PROJECT DESCRIPTION TENANT FINISH IN EXISTING BUILDING  
VACANT LEASE SPACE

Terra Supplements + Superfoods  
Tenant Finish  
1237 NE Douglas Street, Lee's Summit, Missouri

First Floor Electrical  
Project number 2022-26  
Date 3-31-22  
E1  
Scale 1/4" = 1'-0"

2018 IBC

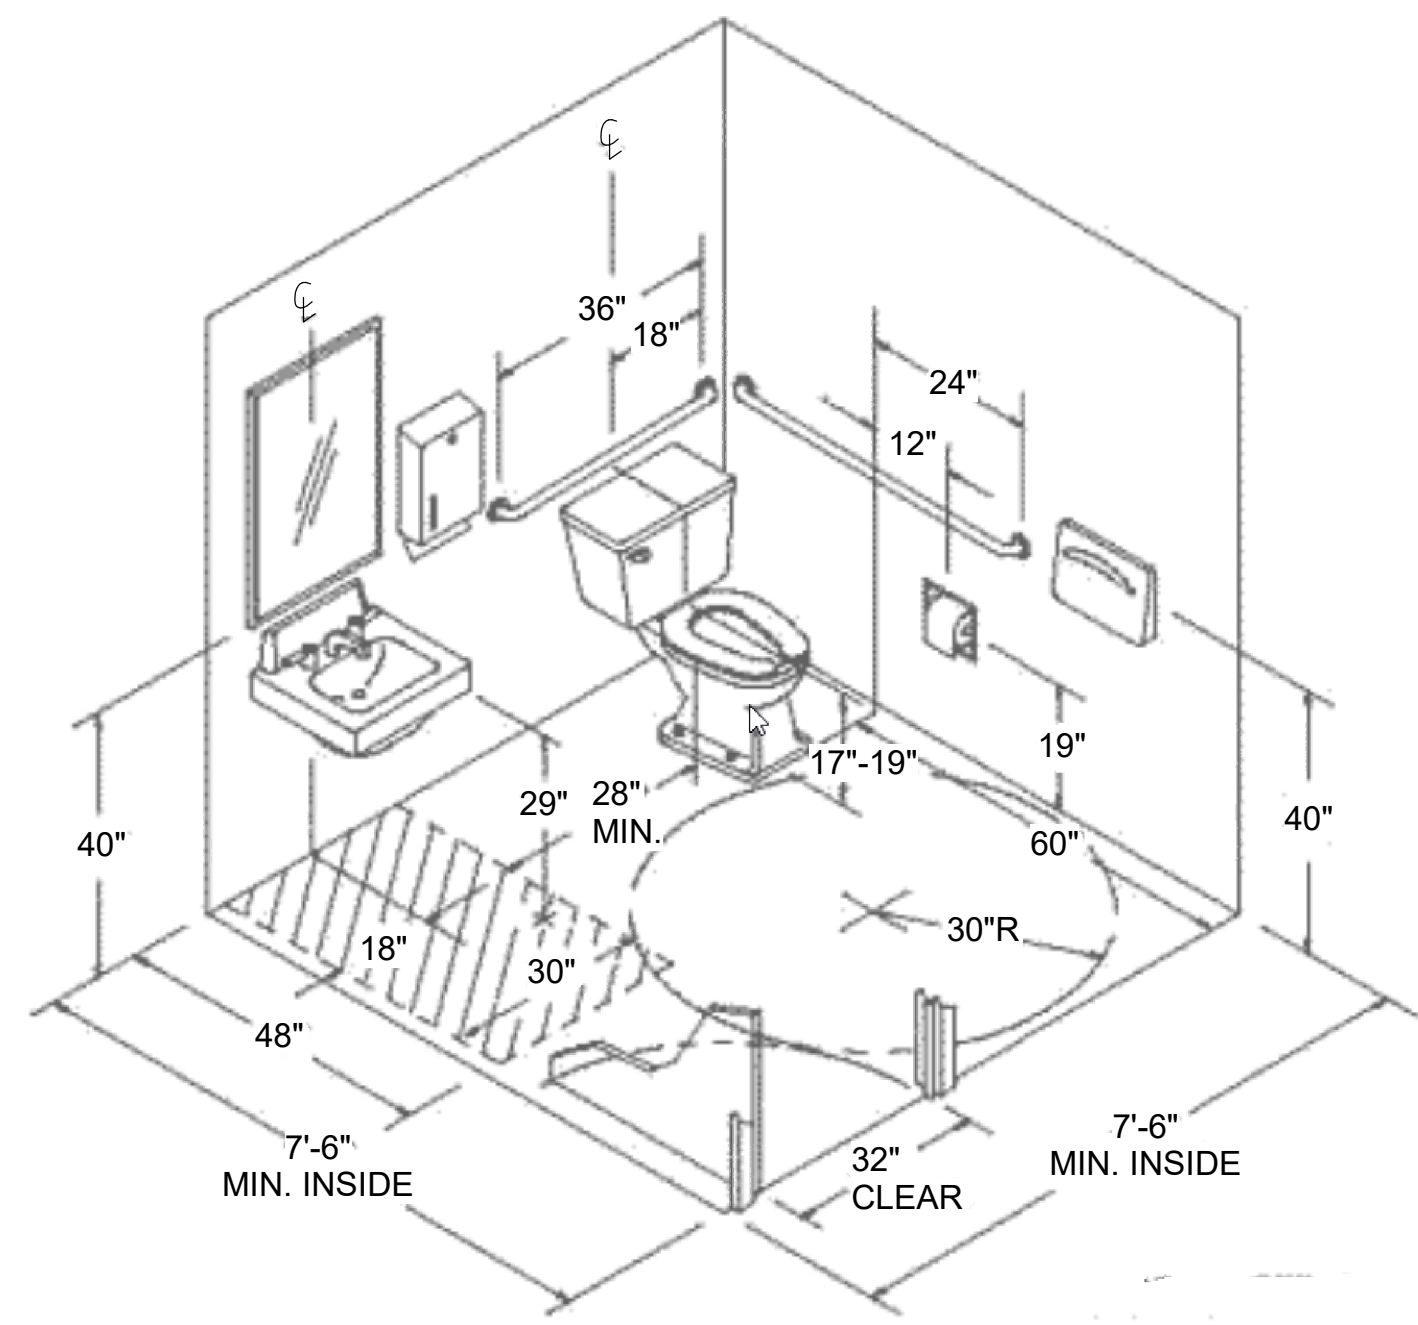
2018 IBC 1209.2 Finish Materials. Walls, Floors and partitions in toilet and bathrooms shall comply with Sections 209.2.1 through 1209.2.4. 2018 1209.2.1 Floors and wall bases. In other than dwelling units, toilet, bathing and shower room floor finish materials shall have a smooth, hard, nonabsorbent surface. The intersections of such floors with walls shall have a smooth, hard, nonabsorbent vertical base that extends upward onto the walls not less than 4 inches. 2018 1209.2.2 Walls and partitions. Walls and partitions within 2 feet of service sinks, urinals and water closets shall have a smooth, hard, nonabsorbent surface, to a height of not less than 4 feet above the floor, and except for structural elements, the materials used in such walls shall be of a type that is not adversely affected by moisture. (See code section for possible exceptions.) 1209.2.3 Showers. (see code for details) 1209.2.4 Waterproof joints. (see code for details) Action required: Provide finish material schedule to demonstrate compliance at water closet and mop sink. If paint is used it must be epoxy based.

1 Floor Plan  
1/4" = 1'-0"

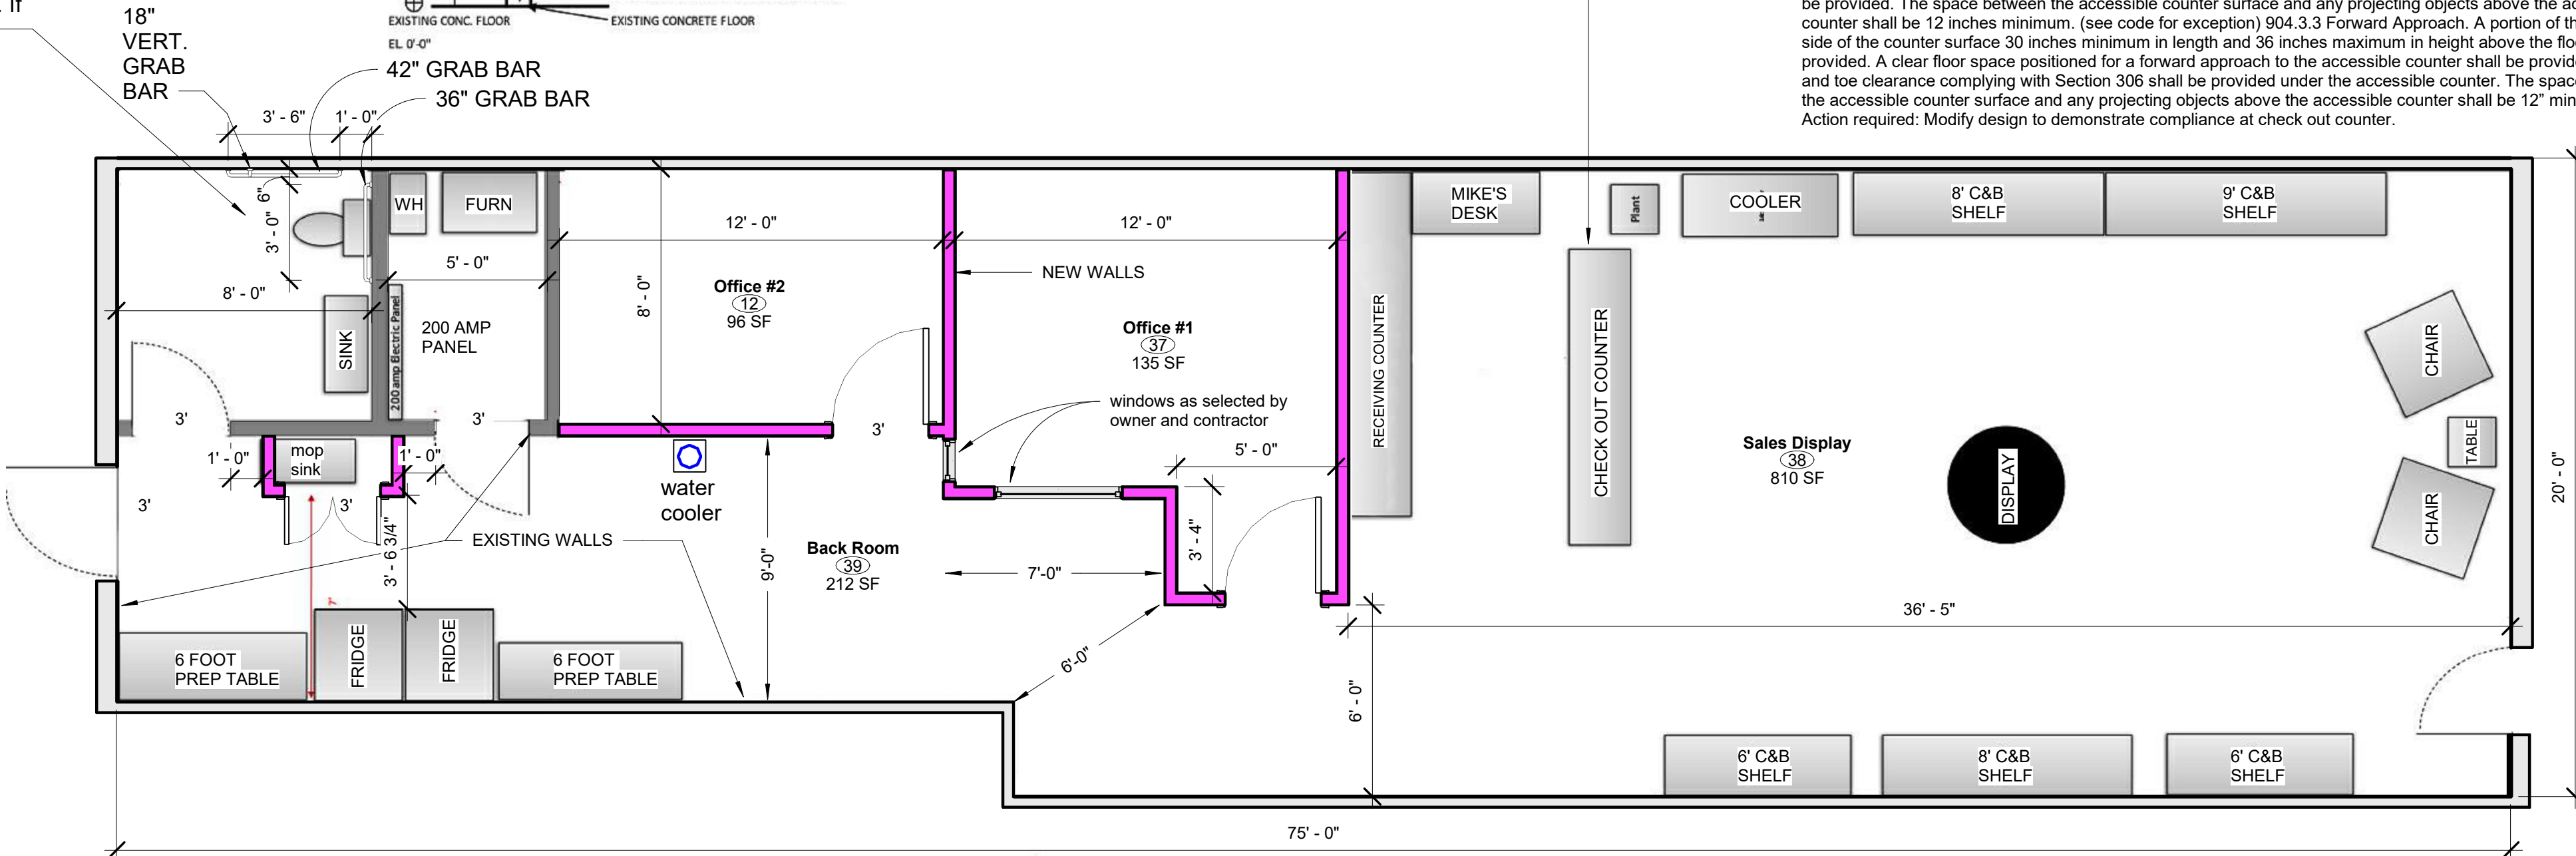
ICC A117.1 Section 904.3 Sales and service counters and windows. Sales and service counters and windows shall comply with Section 904.3.1 and either 904.3.2 or 904.3.3. Where counters are provided, the accessible portion of the countertop shall extend the same depth as the public portion of the sales and service counter provided for standing customers. (see code for exception) 904.3.1 Vertical barriers. At service windows or service counters, any vertical barrier between service personnel and customers shall be at a height of 43 inches maximum above the floor. (see code for exception regarding security glazing) 904.3.2 Parallel Approach. A portion of the public use side of the counter surface 36 inches minimum in length and 26 inches minimum and 36 inches maximum in height above the floor shall be provided. A clear floor space positioned for a parallel approach adjacent to the accessible counter shall be provided. The space between the accessible counter surface and any projecting objects above the accessible counter shall be 12 inches minimum. (see code for exception) 904.3.3 Forward Approach. A portion of the public use side of the counter surface 30 inches minimum in length and 36 inches maximum in height above the floor shall be provided. A clear floor space positioned for a forward approach to the accessible counter shall be provided. Knee and toe clearance complying with Section 306 shall be provided under the accessible counter. The space between the accessible counter surface and any projecting objects above the accessible counter shall be 12" minimum. Action required: Modify design to demonstrate compliance at check out counter.
